TECHNICAL MEMORANDUM

Subject: Seigler Springs North – UP 21-17– Revised Project Information and Response to Review of May 2023 Hydrology Report prepared for UP 21-17

Figure 1. Estimated radius of influence (distance) associated with the project's well (Threshold = 6-inches).

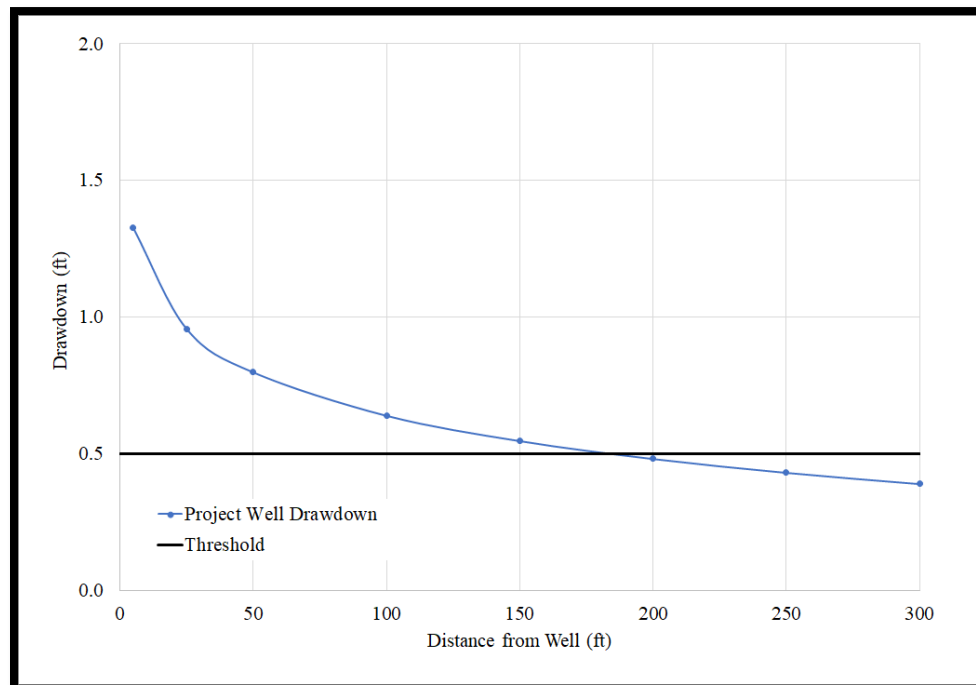
Geosyntec Comment #5: An adequate assessment of cumulative impacts to other water uses in the area was not provided. To provide an accurate assessment of cumulative impacts to the surrounding area, first the orientation and dip of the producing fractures must be known. This information can be obtained by use of the optical televiwer and heat pulse flow meter discussed for Comment 3. For example, if the producing fractures trend towards the northeast or southeast, then pumping on the proposed project well could have significant impact to the existing wells at the Mountain of Attention property.

Geosyntec Comment #5 Continued: In addition, until assessments are made on what the actual well capacity and aquifer recharge values are, operation of this well could dry out fractures in the area also resulting in significant impacts to nearby groundwater wells. Anecdotal information already suggests that fractures may be drying out and not being recharged. Attachment 4 provides two reports from adjacent properties. The first report is a summary of operations of four existing wells at the Mountain of Attention (Figure 1). As indicated in this report, pumping conducted years ago on a specific well (date not specified), supplied 80 gpm, 24-hours a day, 7-days a week. For a test conducted in July 2021, this well only supplied water at 80 gpm 6-hours a day before the well went dry. The well did recharge so that it could be pumped the next day. The second report is a memo from Timothy Toye, a local real estate broker, who indicates knowledge of two wells in the area that have dried up. Both of these reports strongly suggest that the system is being over pumped and not allowing recharge to occur.

Per Geosyntec's comment letter, The Mountain of Attention Sanctuary operated by the Adidam Holy Domains has multiple wells and the nearest well operated by the Mountain of Attention is located 2,921 feet to the west of the proposed project. The radius of influence of the project well was estimated using the Theis equation (Fetter, 2001). The Theis equation was developed to model the response of a confined aquifer to pumping. Using the Theis equation, the drawdown at a specific distance from each well can be estimated based on the project's maximum irrigation pumping

demand, 10 gpm, over a duration of 22 hours (Attachment 4). The radius of influence is the distance where the modeled cone of depression from groundwater extraction (drawdown) under these conditions is negligible (less than 6-inches), which is less than 200 feet from the project well (Figure 1), over 2,700 ft (0.5 miles) from the Mountain of Attention Sanctuary wells.

Response: Attachment 4 referenced by Geosyntec does provide enough information regarding the wells at Mountain of Attention and why they went dry. There are many reasons a well can go dry, construction issues, over pumping, maintenance, seasonal fluctuations, pump installation level, location, etc. Of the four existing wells at the Mountain of Attention, the report indicated that the other three wells are still working and providing water. Also, the wells are over 2,700 feet away from the project well. The information provided does not provide evidence that the project well would go dry. In addition, as discussed previously, the project proposes continuous groundwater level monitoring.

Figure 2. Screened well interval (SI) elevations and ground surface elevations.

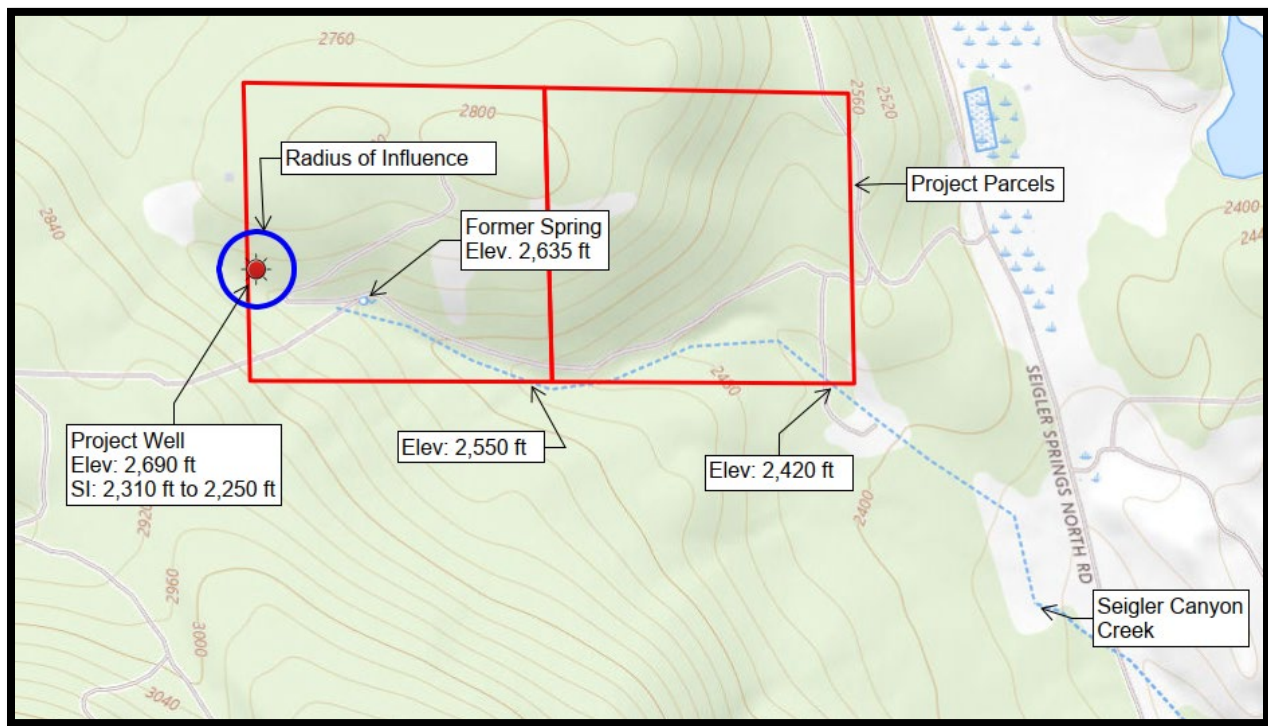
Geosyntec Comment #5 Continued: The report also did not assess the presence of springs in the area that could be sourced from this aquifer system. A map showing where springs are located and study to assess potential impacts to these features needs to be completed and if impacts affect surface water flows. In addition, the geologic map provided in the Northpoint report indicates there are faults in the area including one that goes through the project area. The impact on water movement from these faults should be assessed for this project.

Response: The USGS topographic maps indicate a spring approximately 500 feet west of the well. The Biological Resources Assessment prepared by Natural Investigations (dated November 2020) for the project did not identify any springs on site and stated that, “a spring is indicated on the USGS topo map, but no spring could be found at the top of the watercourse”. That being said, the location of the spring is located outside of the radius of influence of the well. The surface elevation of the spring is approximately 325 feet above the screened interval of the well, which starts at an elevation of approximately 2,310 ft and ends at an elevation of approximately 2,250 ft, well below the elevations of the ephemeral streams in the vicinity of the project parcels (Figure 2). The project well extracts water from a confined volcanic water bearing unit, well below surface water, and is a non-diversionary water source.
